Request to vary the Regional Land Transport Plan for Taranaki 2015-2021

Purpose:	To enable the Regional Transport Committee of the Taranaki Regional Council to consider a request for a variation to the <i>Regional Land Transport Plan for Taranaki 2015-21</i> (RLTP).
Requesting organisation:	South Taranaki District Council
Contact person/s:	Vincent Lim
Variation request:	Add new project - Upgrade of rail level crossing at Nukumaruru Station Road.
Background to variation request <p>Due to the proposed Nukumaruru Station Road with the associated increased in traffic volume across the existing rail level crossing, Kiwirail has requested for a Level Crossing Safety Impact Assessment (LCSIA) to be carried out. The Safety Review Team (SRT) has identified improvements to the rail level crossing to reduce the risk score to an acceptable level. The recommended improvements or upgrade are listed as follows:</p> <ol style="list-style-type: none"> 1. Installation of flashing lights and bells on all approaches to the level crossing. 2. Reshaping the cut face to improve visibility of any approaching train (we expect this is unlikely to occur as may need private land to achieve). 3. Lifting up th

Figure 2-3: South Bound Approach

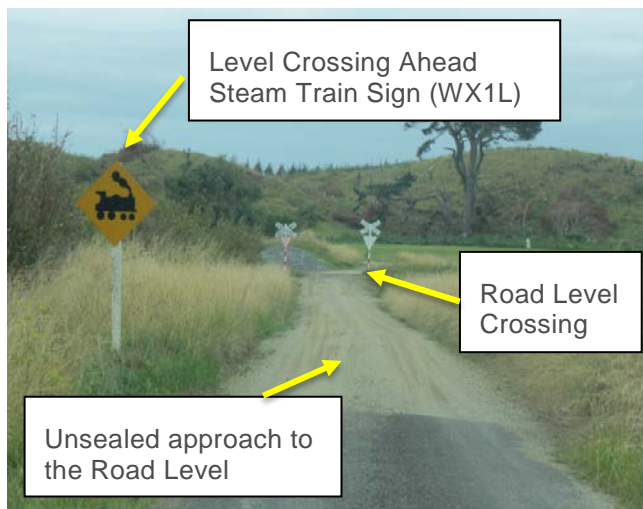
1. On the south bound approach to the level crossing a Level Crossing Ahead Steam Train sign is provided on the right hand side of Nukumarū Station Road. This sign looks fairly old and likely to have lost its reflectivity over time. This sign is easy to spot during day time but would be hard to identify during adverse weather or low light conditions. We suggest this sign is replaced when the crossing is upgraded.

2. There is no Level Crossing Ahead Steam Train sign on the north bound approach to the level crossing. This could be due to Nukumarū Station Road being a no exit road and the level crossing located towards the end of this road. Level Crossing Ahead Steam Train sign helps warn the drivers that they are approaching a railway level crossing and to expect trains. Ideally a compliant Level Crossing Ahead Steam Train sign should be installed on each approach to the road level crossing, especially given traffic volumes are expected to rise significantly in the future.

Figure 2-7: Nukumar Station Road Extension Proposed Alignment

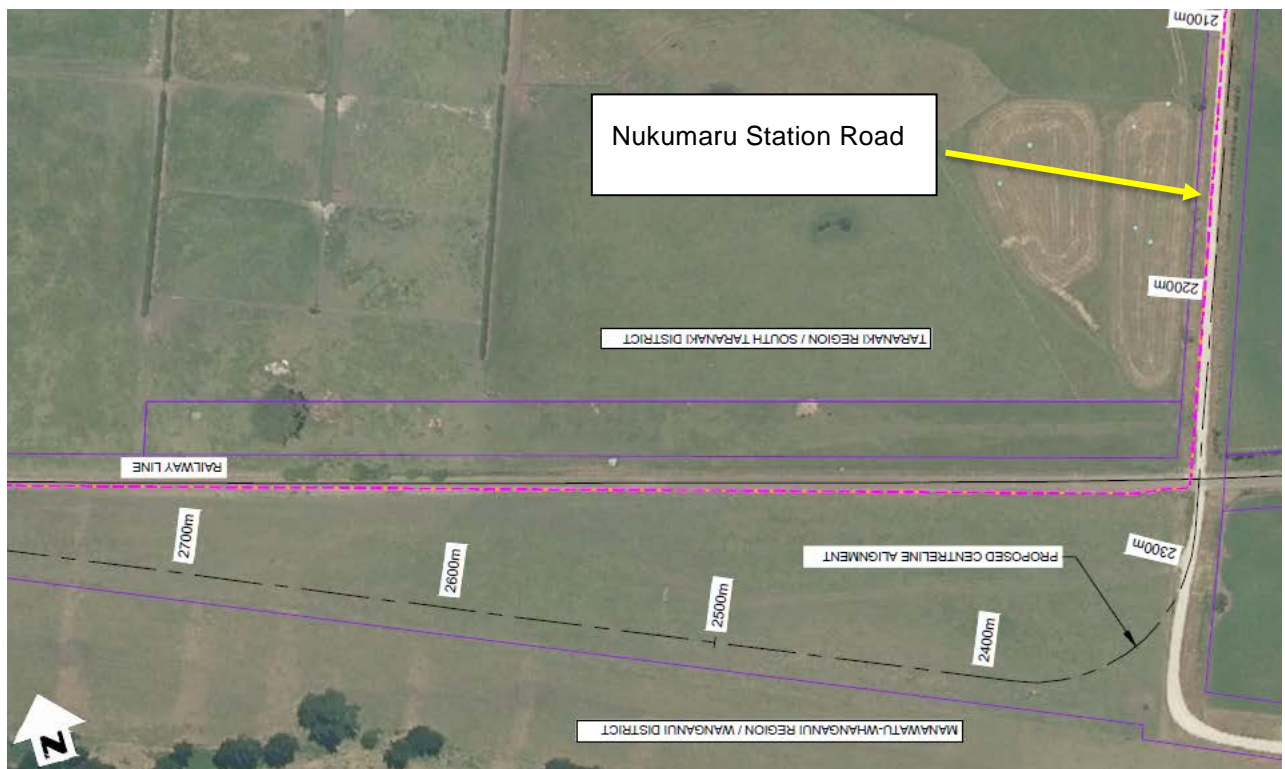
The proposed design does not show any improvements to the road level crossing point. So it is assumed that the proposed design retains the existing give-way priority controls. With the extension works this will no longer be a dead-end road. Given the increased traffic volume and the 100km/h posted speed limit on a sealed road, it is likely that the level crossing needs to be upgraded to address the increased crash risk. This has been considered in the modified design that has been developed.

The following safety deficiencies have been identified. These deficiencies need to be addressed prior to the road being connected to SH3:

1. The current crossing has no active control, such as flashing lights and bells. While passive controls (in this case a give-way control) are currently provided this is typically not suitable when the traffic volumes are at 500vpd. We would strongly recommend that flashing lights, bells and cross buck sign assembly be installed on both approaches to this level crossing.

2. Due to the north bound horizontal curve on approach to the level crossing forward visibility of the flashing lights, bells and cross bucks assembly at the level crossing will be limited. Consideration should be given to installing a level crossing ahead advance warning (WX3) sign. The orientation of the flashing lights should also be aligned so that drivers can see it when they are on the approach curve.

3. No Rail X pavement markings are proposed for this site. Rail X pavement marking help warn the drivers of the upcoming railway level crossing and are a requirement for sites which have posted speed limit of 70km/h or higher. Rail X pavement marking should be installed at this site as part of the project.

4. The current approaches to the level crossing are in a sag curve. Consideration should be given to lifting the road up on the approach to the level crossing to improve visibility of the approaching trains and to remove the existing sag which could potentially cause heavy vehicles to bottom out at the level crossing.

5. The existing cut face to the west of the level crossing currently restricts visibility of the approaching trains. The sight distance (S2) required and measured as per the ALCAM LXM Rail Detail is 155.69m and 127m respectively. Consideration should be given to reshaping the cut face to improve visibility of any approaching train. The road approaches currently meet the stop sign requirement but due to the proposed sealed approaches, potential high approach speeds and general user noncompliance of the stop signs flashing lights and bells should be installed at this site as a minimum improvement.

SOUTH TARANAKI DISTRICT COUNCIL
NUKUMARU STATION ROAD EXTENSION
PROPOSED SURVEY PLAN

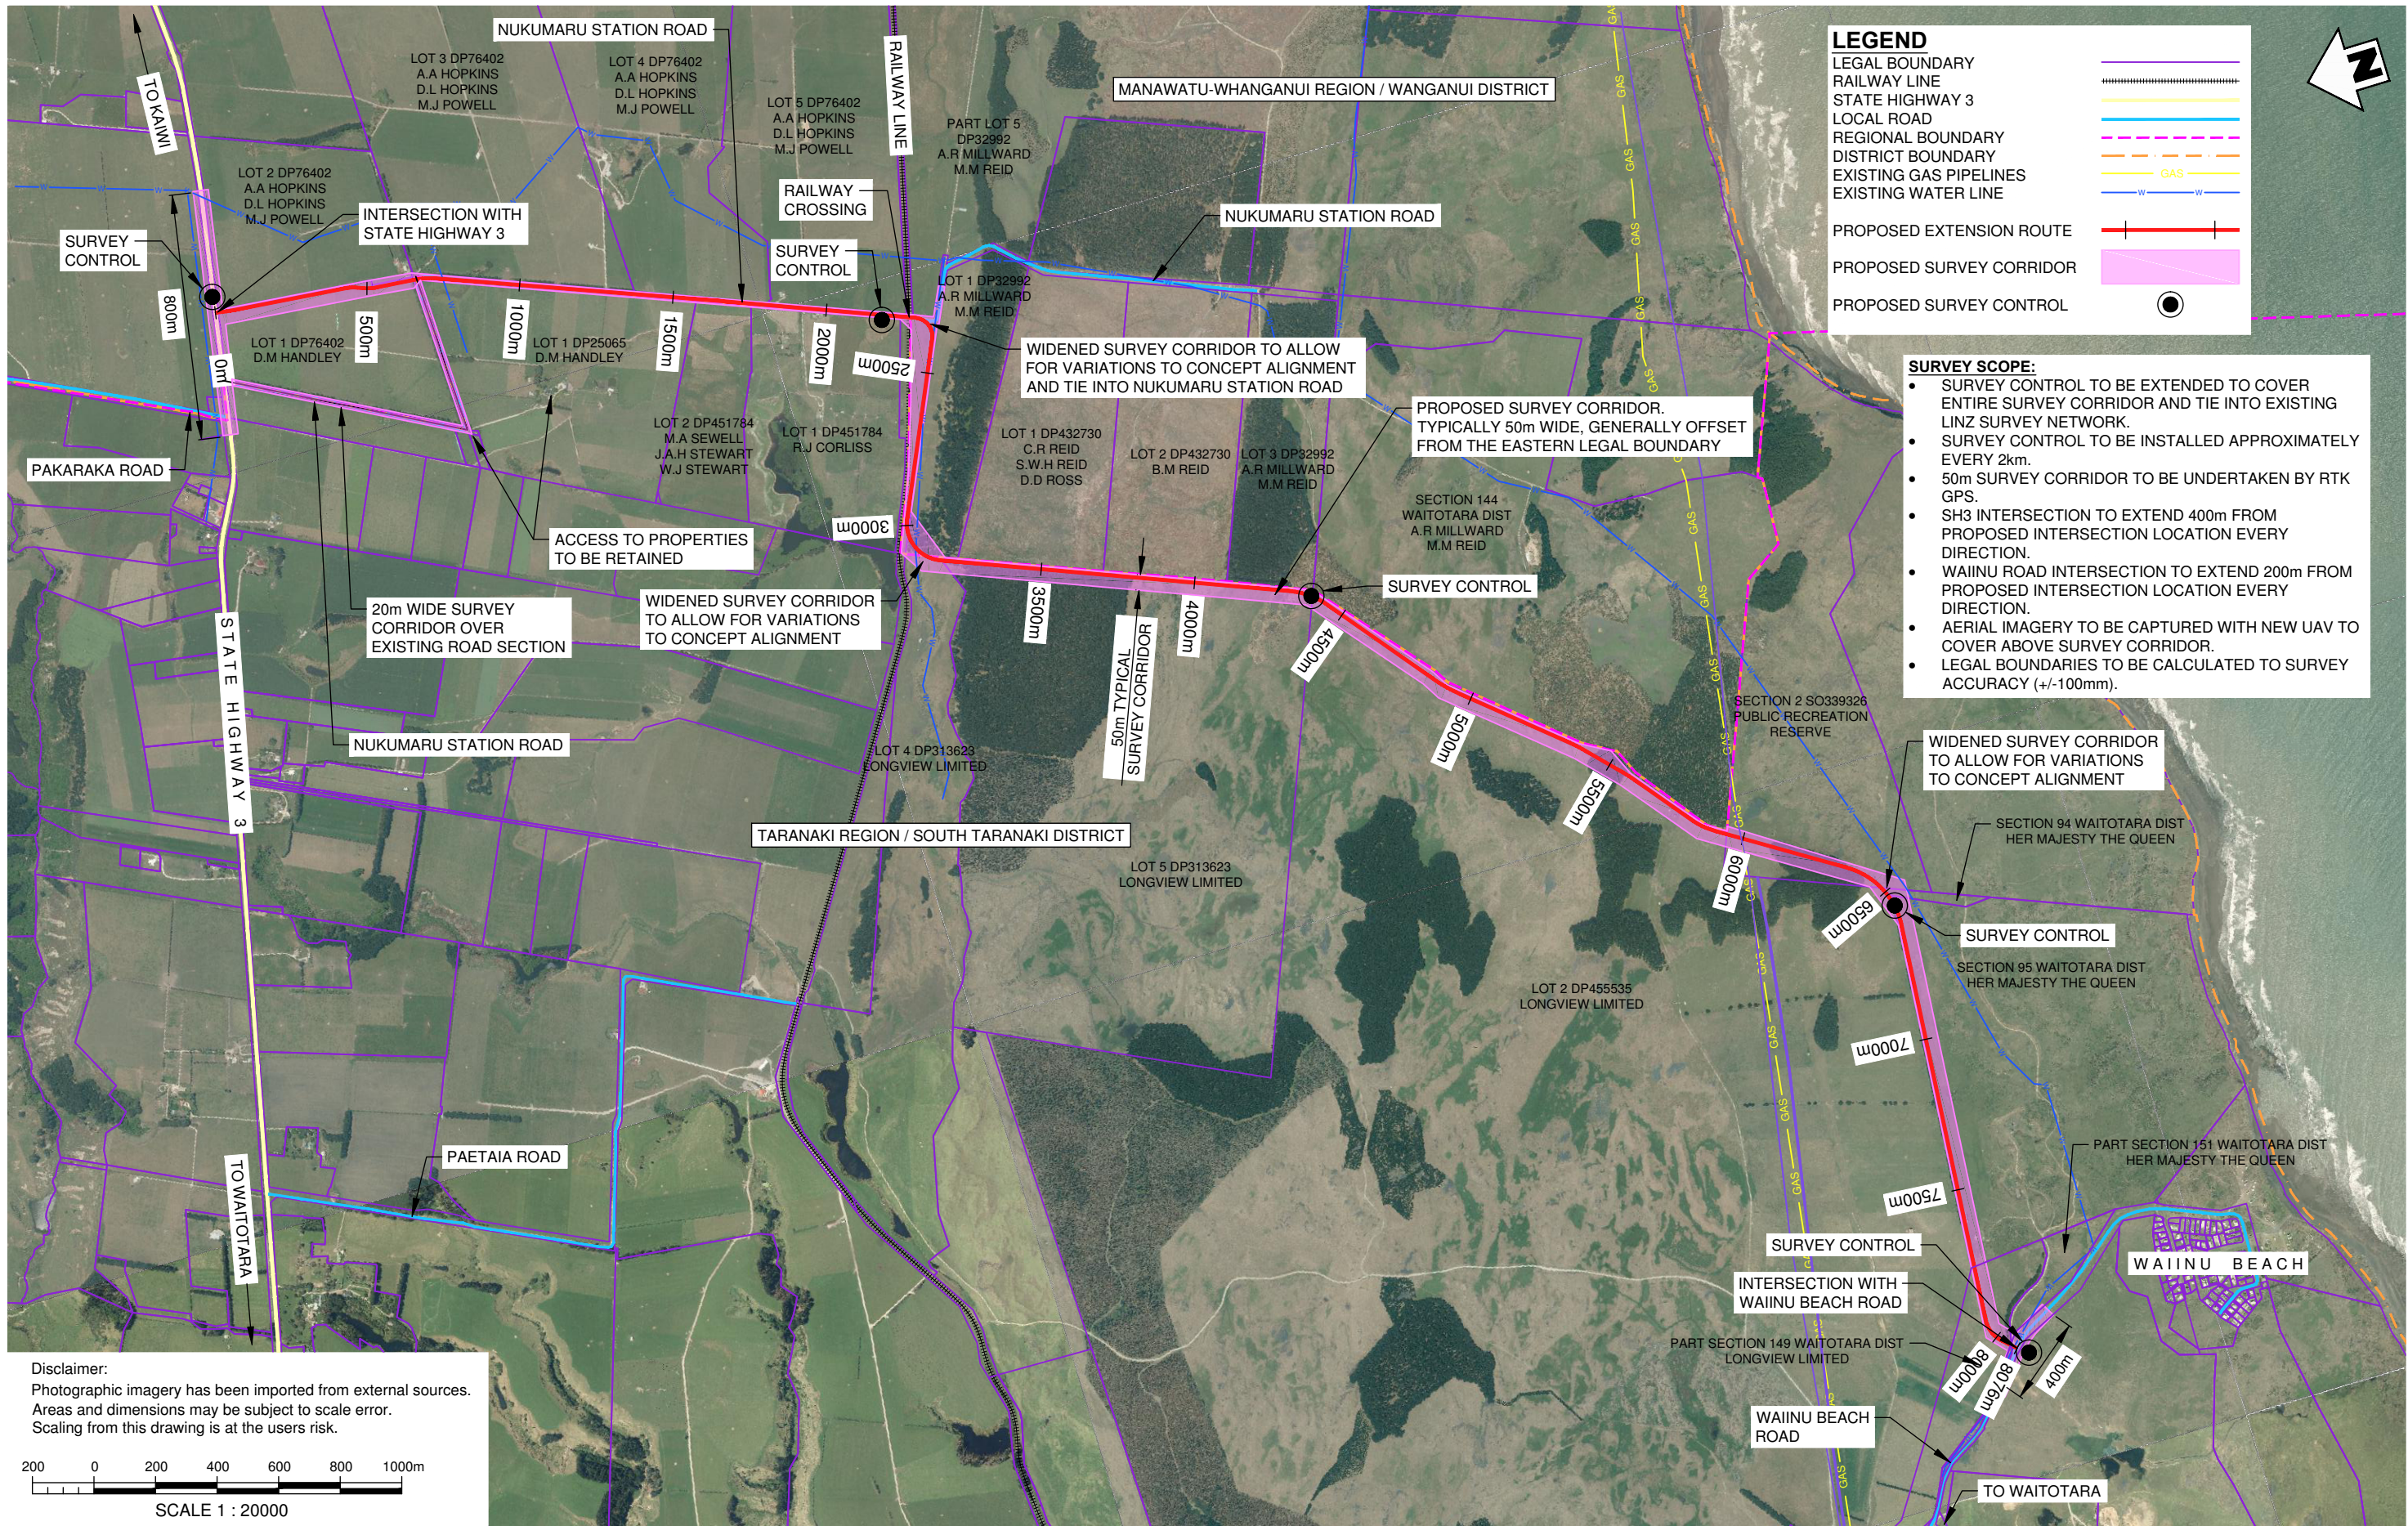
1. Flashing Lights and Bells	Significant
The design does not show provisions for flashing lights and bells. Flashing lights and bells activate when a train approaches the level crossing and gives drivers with visual and audible queues that a train is approaching. Flashing light and bells should be installed at this site as a minimum.

2. Visibility of the Approaching Train	Significant
Existing cut face to the west of the level crossing currently restricts visibility. Consideration should be given to reshaping the cut face to improve visibility of any approaching train.

3. Heavy Vehicle Grounding Out	Moderate
Current approaches to the level crossing are in a sag curve followed by a hump at the level crossing This can potentially lead to heavy vehicles bottoming out and being stranded on the tracks. If a train happens to arrive at the same time then the result would be devastating. Consideration should be

given to lifting the road up on the approach to the level crossing to improve visibility of the approaching trains and to prevent vehicles bottoming out. It was unclear from the details provided whether such changes are proposed.

Reference should be made to the required standards for the design of this road level crossing. E.g. Traffic Control Devices Manual (Part 9) – level crossings and any KiwiRail design requirements etc.

Consider installing Rail X pavement marking at this site as the posted speed limit on the proposed sealed road will be 100km/h.

There are no signs on the provided drawing, the following are signs that should be included at this site as a minimum;

- Level Crossing Ahead Steam Train (WX1L) sign on both approaches to the level crossing. These signs can be duplicated if there are visibility restriction to the LHS sign or to provide with added emphasis of the level crossing ahead.
- Assemblies are unlikely to be clearly visible on the north-bound approach due to the proposed horizontal curve. Consideration should be given to installing a level crossing ahead advance warning (WX3) sign.
- Install cross buck sign on both approaches
